SUBJECT: NC 68/US 220 Connector from NC 68 at SR 2133 to the  
existing intersection of NC 68 and US 220 in Guilford and  
Rockingham Counties; WBS No. 34429.1.1  
**TIP R-2413A**

Also reference your letter to the Corps dated September 25, 2014 (received October 6, 2014), requesting modification of the permit for a net decrease in permanent impacts to streams and a net increase of temporary impacts to streams, for revisions to Sites 1, 2, 3, 4, and 22.

Subject: Modification to the 401 Water Quality Certification Pursuant to Section 401 of the Federal Clean Water Act and Jordan Lake Buffer Rules for the proposed new facility from SR 2011 to the Haw River at US 220 Guilford County; WBS No. 34429.1.1; TIP No. R-2413A; NCDWR Project No. 20130517 version 3.

## R-2413A Permit Drawing Update Summary

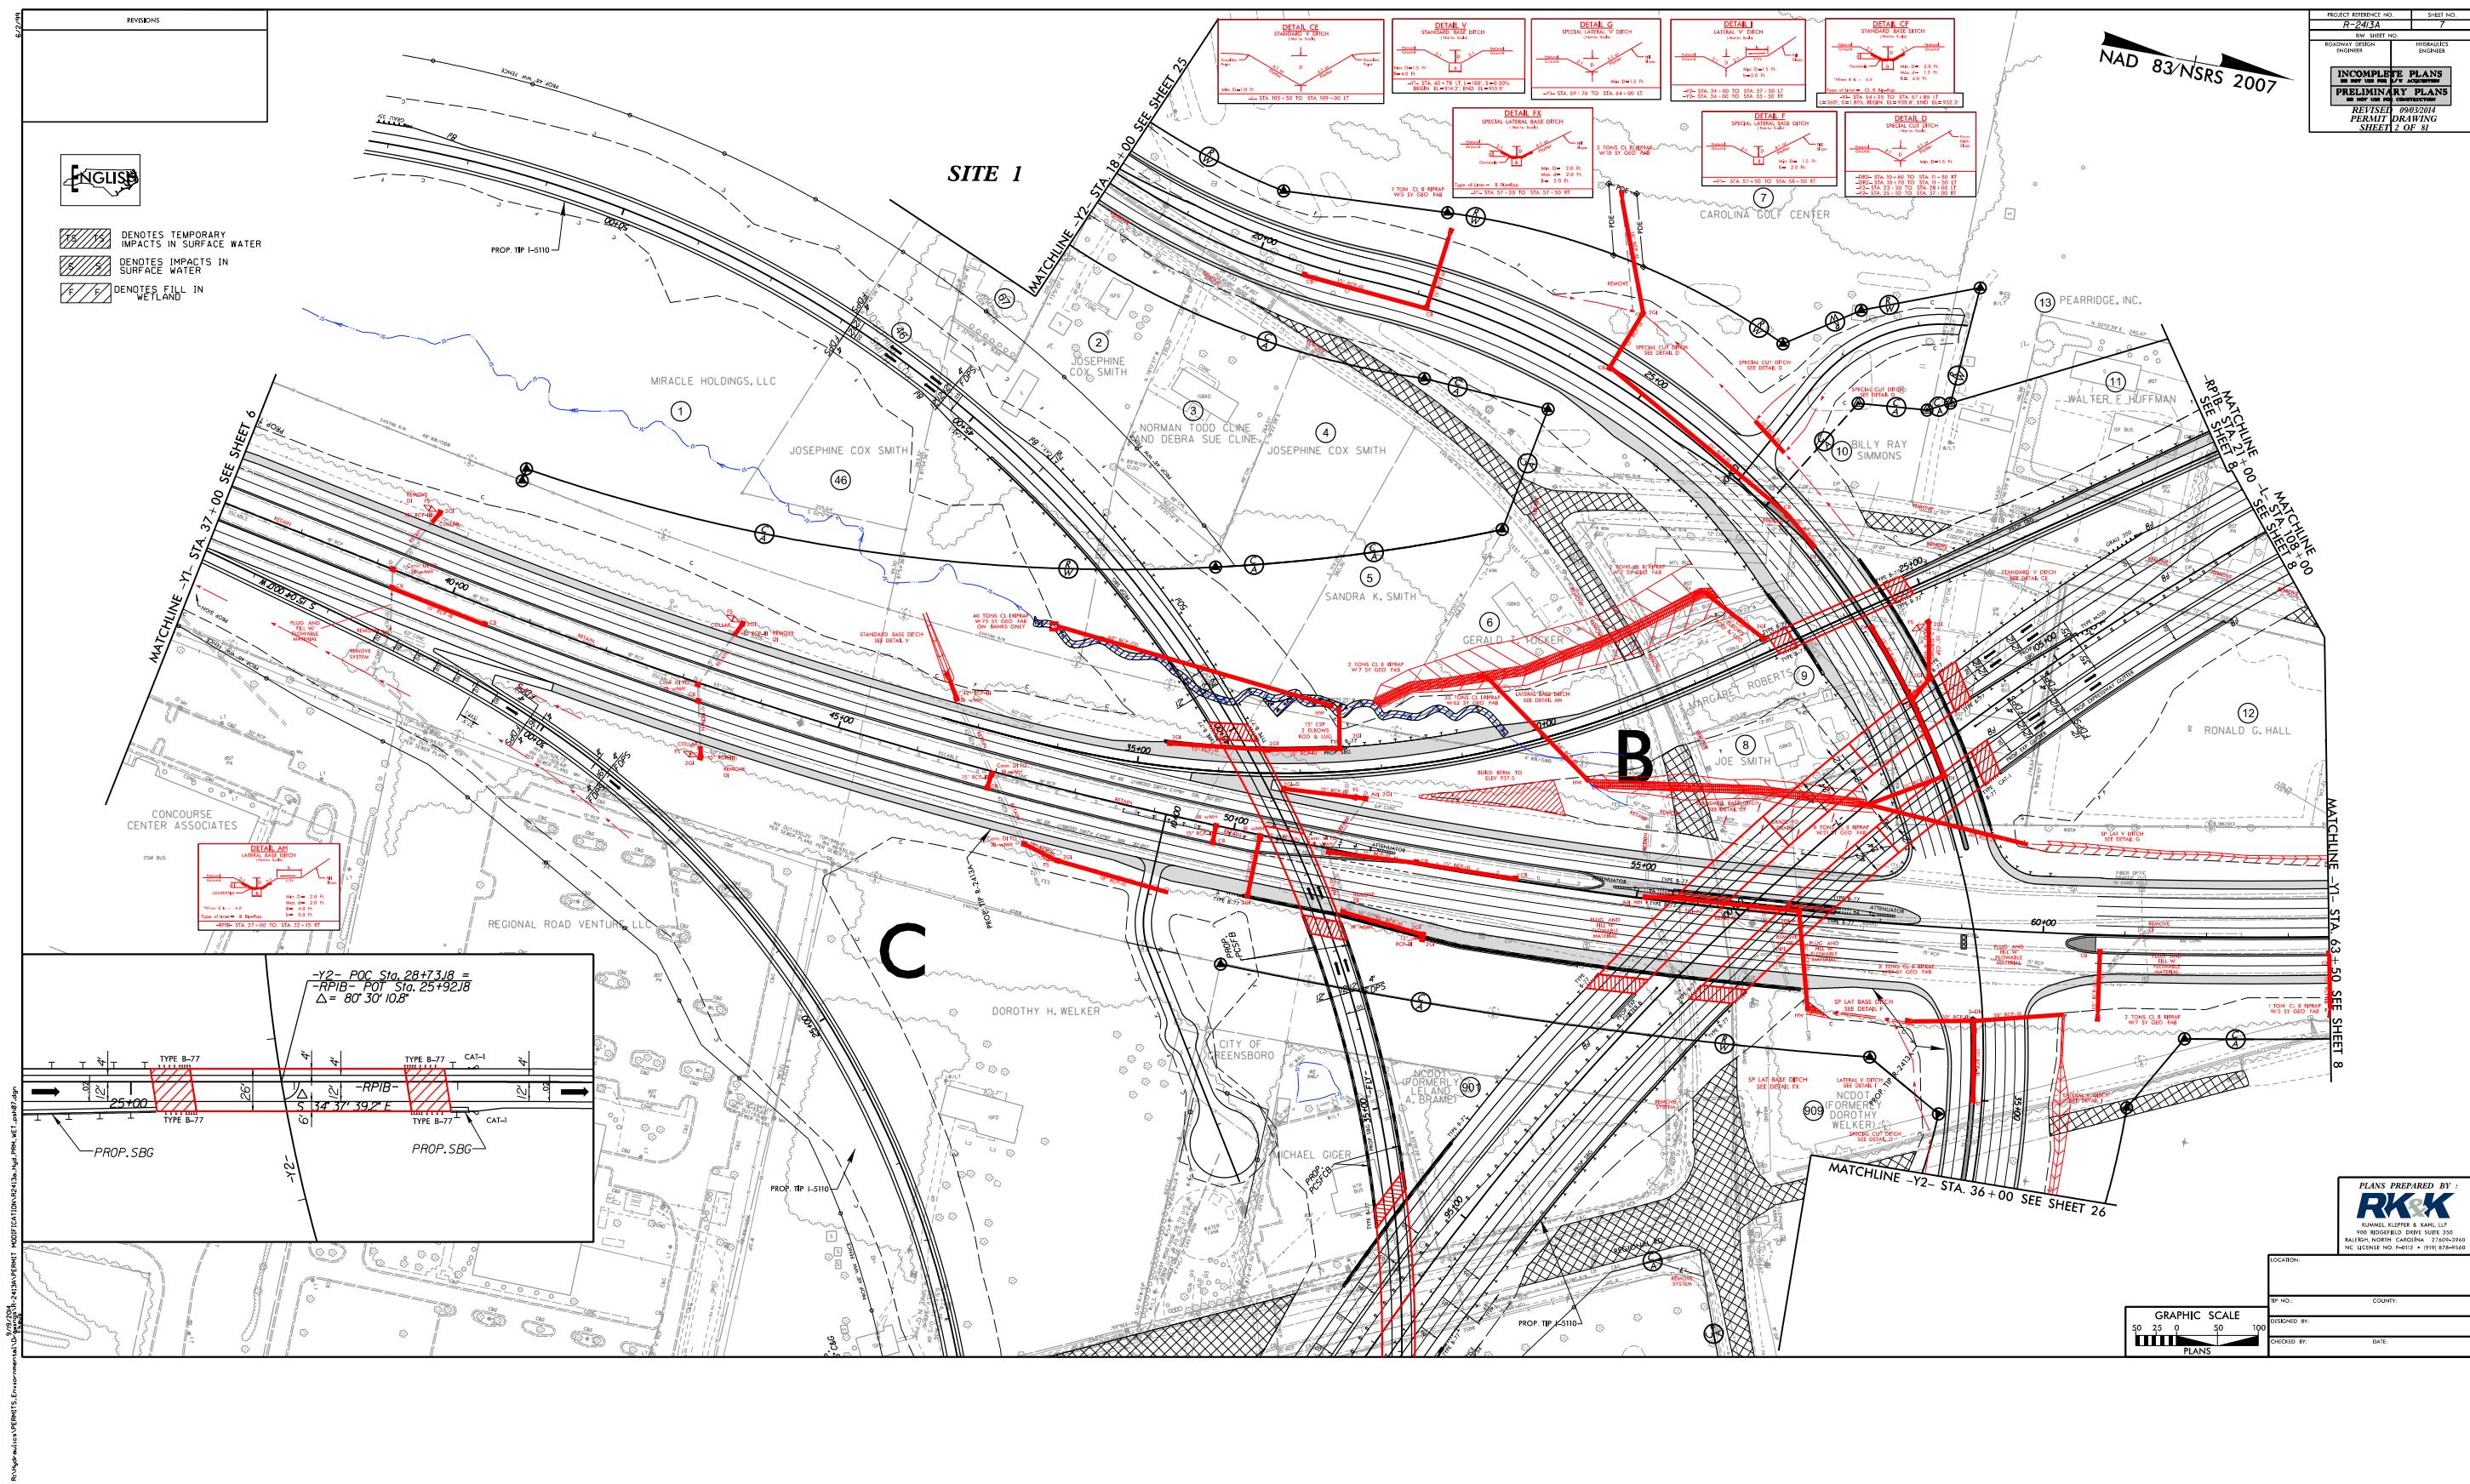
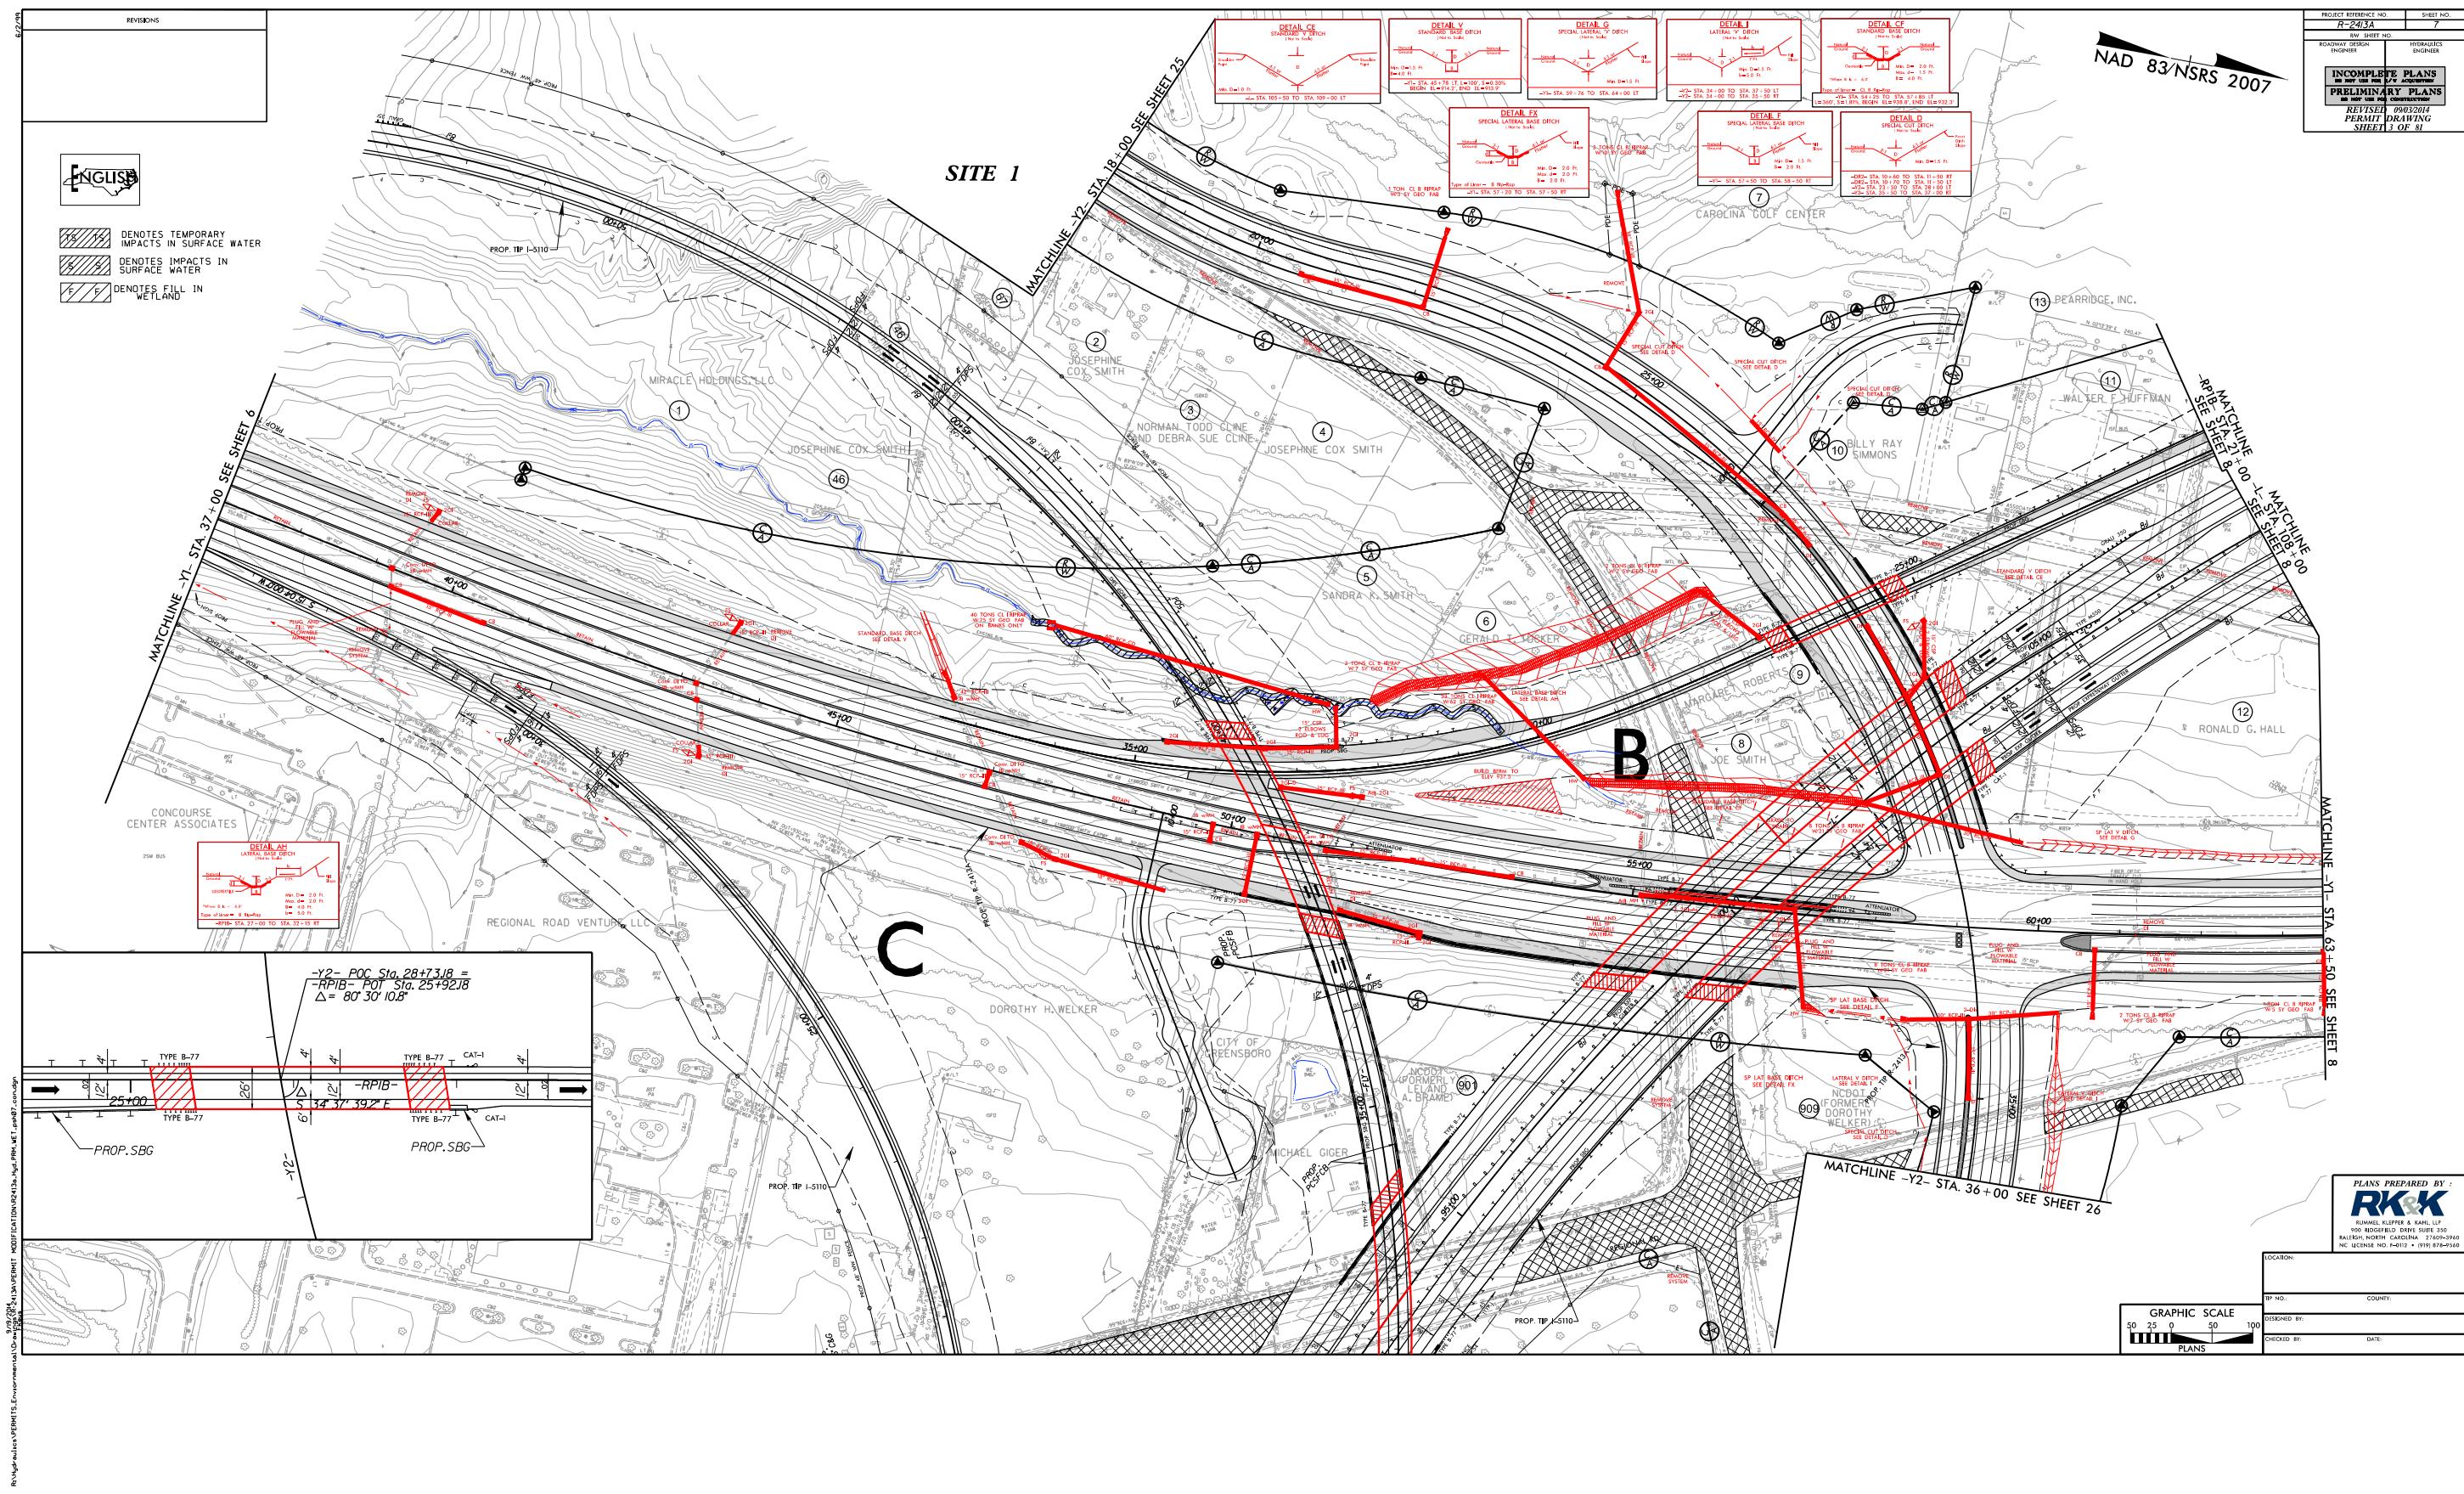
Permit Drawings	Plansheets	Site No.	Comments
1 of 81	1	N/A	Cover sheet Added Site 23 (left off original cover), adjusted location circles to be more accurate , includes current prepared by names etc
2-4 of 81	7	1	Permit Modification
4A of 81	Pipe Profile	1	Permit Modification
5 of 81	X Section	1	Original
6-7, 9-10 of 81	8,37	2,3	Permit Modification
8 of 81	Pipe Profile	2C	Original
11-13 of 81	9	4,5	Permit Modification
14 of 81	X Section	4	Original
15 of 81	9	5	Revised Minor system realignment from 0955-0953; Cross pipe 1801 changed from 66" to 60"
16 of 81	Pipe Profile	5	Original
17-19 of 81	12	6	Revised 1113-1115 changed from 2-54" to 48"
20 of 81	Pipe Profile	6	Original
21-23 of 81	13	7	Revised Minor system realignment from 1212-1213, 24" to 18", 54" to 48"
24 of 81	Pipe Profile	7A	Original
25-27, 29-31 of 81	14	8/9	Revised Minor system realignment from 1412-1414
28 of 81	Pipe Profile	8B	Original
29-30, 32-34 of 81	15, 16	9/10	Revised Minor system realignment from 1507-1508

32-34 of 81	16	10/11	Revised Minor system realignment from 1601-1602
35-36 of 81	Pipe Profile/X Section	10	Original
37-39 of 81	17	12	Revised system and ditches
40 of 81	Pipe Profile	12	Original
41-43 of 81	18	13	Revised Minor system realignment from 1801-1802; Cross pipe 1801 changed from 54" RCP to 60" RCP
44-46 of 81	20	14	Revised Cross pipe 2006 changed from 78" CSP to 72" CSP
47 of 81	Pipe Profile	14	Original
48-50 of 81	21	15,16	Revised undetectable system realignment from 2108-2111, 2113-2115, additional toe protection
51-52 of 81	Pipe Profile/X Section	16	Original
53-55 of 81	22	17,18	Revised Minor system realignment from 2208-2212, 2212-2215 pipe gauge changed
56-58 of 81	Bridge Profile/X Section	18	Original
59-61 of 81	23	19	Revised Minor system realignment from 2310-2311
62 of 81	Pipe Profile	19	Original
63-65 of 81	31	20	Revised Minor system realignment from 3101-3102
66 of 81	X Section	20	Original

66A-66C of 81	33	23	Revised Cross pipe 3305 changed from 30" CSP to 36" CSP
67-69 of 81	34	21	Revised undetectable system realignment from 3409-3410, additional toe protection and ditches
70-71 of 81	Pipe Profile/X Section	21A	Original
72-74 of 81	37	3,4	Permit Modification
75 of 81	X Section	4	Original
76 of 81	37	22	Permit Modification
77 of 81	Sill Detail	22	Original
78 of 81	Permit Impact Summary		Permit Modification
79-80 of 81	Permit Impact Summary		Original
81 of 81	Permit Impact Summary		Permit Modification
